Re: EnCana Oil And Gas Partnership (EnCana) Application No. 1394112
Canadian Natural Resources Limited (CNRL) Application No. 1409180
Husky Oil Operations Limited (Husky) Application No. 1481725
Cold Lake Oil Sands Area – Clearwater Deposit

**Response of EnCana Oil and Gas Partnership (EnCana) to
Board Staff (Board) Questions on Gas Flanking Bitumen Cases from EnCana's
April 5, 2007 Submission**

Figure 1: Geological Configuration - Revised FL 19 Gas Flanking Bitumen

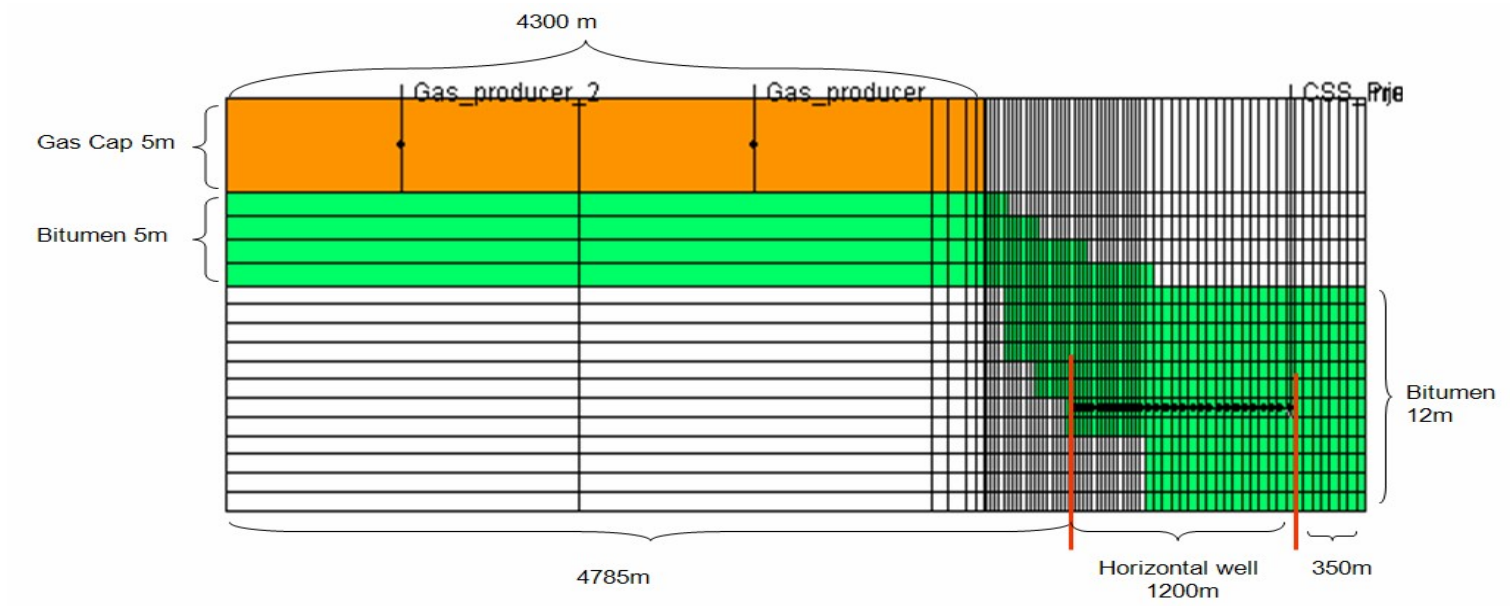
- (a) It appears that the steam injection pressure was significantly below the dilation pressure (injection pressures were 4500 kPa or lower compared to a dilation pressure of 9800 kPa). Explain how these cases assess the impact of gas production on flank bitumen recovery using high pressure HWCSS instead of low pressure HWCSS.
- (b) Explain how these cases are representative of the conditions existing in the CNRL lease area.
- (c) It appears that the relative permeability curves used for the revised flank 19 cases were different than the relative permeability curves used for the original flank 19 cases and the relative permeability curves used in the CNRL model. Explain why EnCana used different relative permeability curves.

- (a) EnCana's gas flanking bitumen case input and output files submission of April 5, 2007 involved a revision of the original Flank model FL 19 and incorporated a rough geological configuration of the reservoir in the general area of the Piezometer 00/13-10-068-03W4/00 (Piez 502) as presented in Figure 1. The original FL 19 model was revised to allow the pressure distribution in the flank area, after gas cap depletion to 200 kPa, to be close to or lower than 1900 kPa calculated^{1,2} by CNRL as the expected pressure in

- (b) As per discussions in item IR-a) above, the geological configuration of the revised FL 19 model (Figure 1) is a rough representation of that in the area of the 00/13-10-068-03W4/00 Piezometer in the CNRL lease area. Figure 5 is the pressure distribution in the rerun FL 19 gas flanking bitumen model at the end of the conventional gas production phase in the model on December 31, 2006 and prior to start of steam injection operations in the model.
